# Exclusion of 25 deg F Embrittlement in Topical Report PWROG-15109-NP

David Dijamco  
Technical Reviewer  
Office of Nuclear Reactor Regulation  
Division of Materials and License Renewal

2019 Annual Materials Exchange Public Meeting  
May 21-22, 2019

# Summary of Technical Basis in PWROG-15109-NP for excluding 25°F

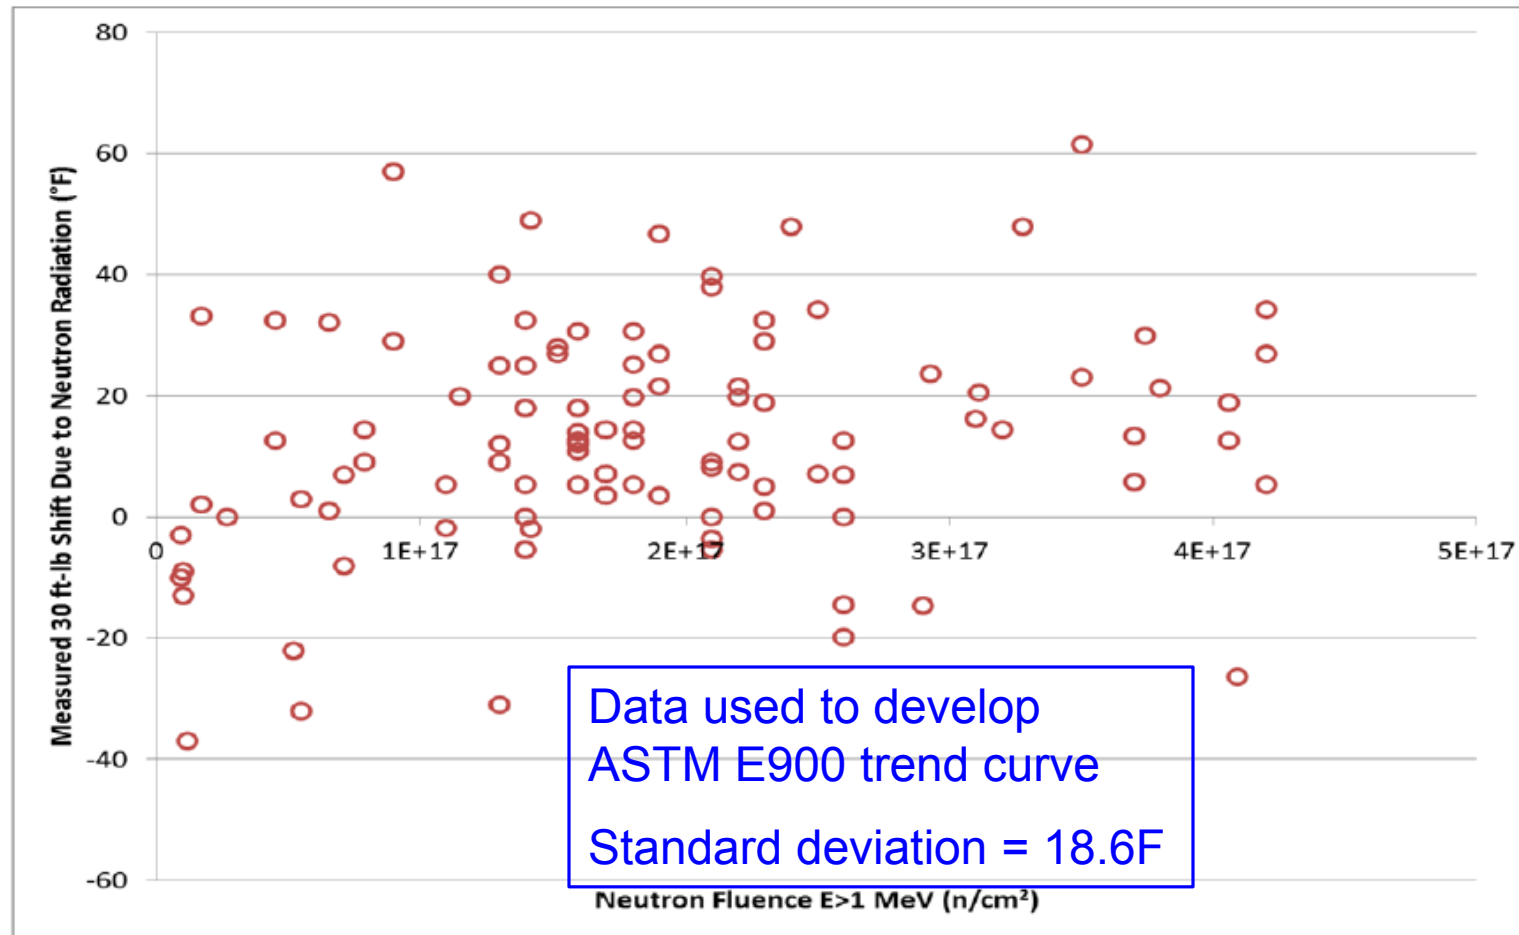
- 18.6F < 25F  
but
  - Reasonable compared to standard deviation from known embrittlement trend curves for forgings:
    - 17F (RG 1.99, Rev 2)
    - 18.6F (10 CFR 50.61a, Cu ≤ 0.072 wt %)
    - 19.6F (10 CFR 50.61a, Cu > 0.072 wt %)
- and
  - For RPV mat'l with high Cu (highly embrittled),  $\Delta RT_{NDT}$  at  $0.99 \times 10^{17}$  n/cm<sup>2</sup>
    - 24.5F (Cu = 0.30 wt %)
    - 25.4F (Cu = 0.28 wt %)
    - 29.6F (Cu = 0.35 wt %)

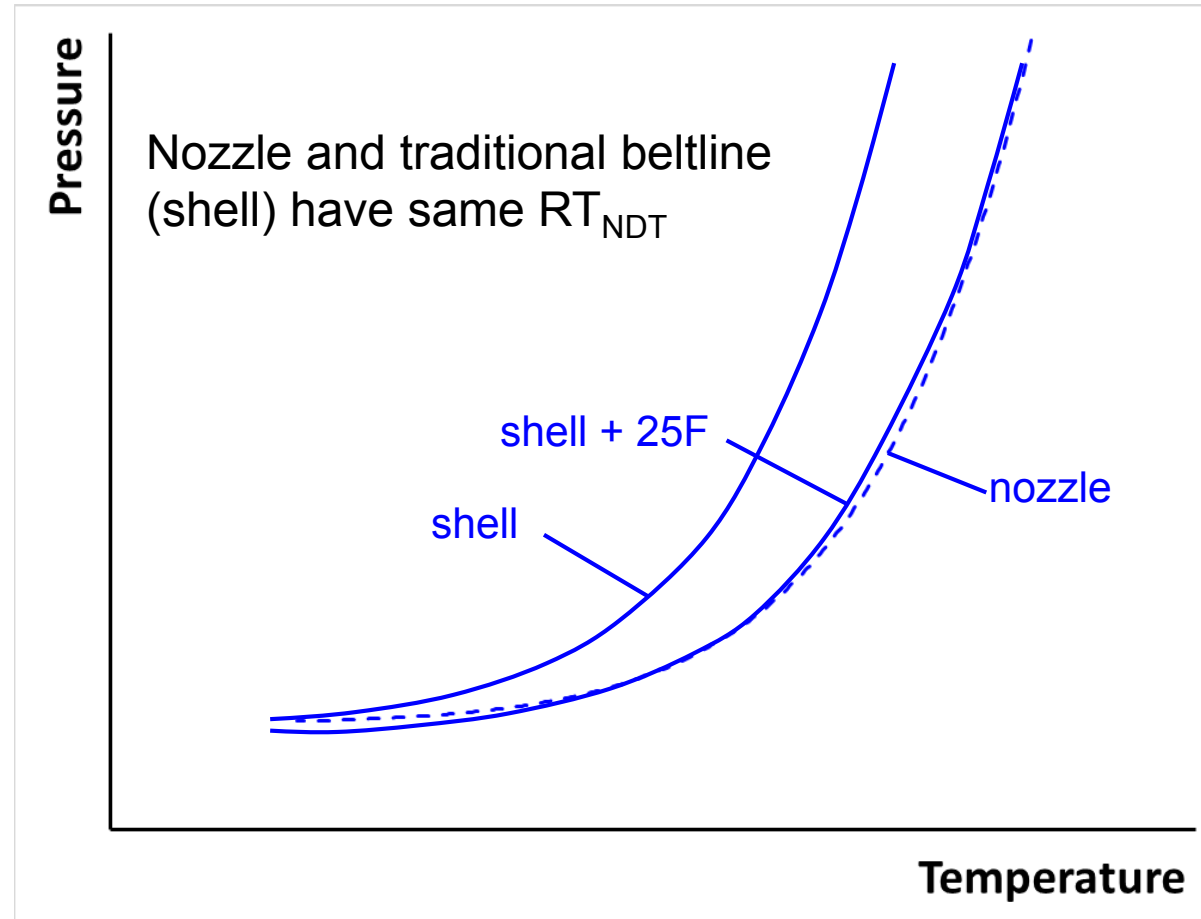
- Independent safety assessment
  1. Conservative

$$\text{ART} = \underset{\substack{\uparrow \\ 43F}}{\text{init RT}_{\text{NDT}}} + \underset{\substack{\uparrow \\ 25F}}{\Delta \text{RT}_{\text{NDT}}} + \underset{\substack{\uparrow \\ 2\sqrt{(0^2 + 12.5^2)}}}{2v(\sigma_i^2 + \sigma_{\Delta}^2)} + \underset{\substack{\uparrow \\ 25F}}{25F}$$

$$= 118F$$

due to bounding stress difference between nozzle corner and shell geometry
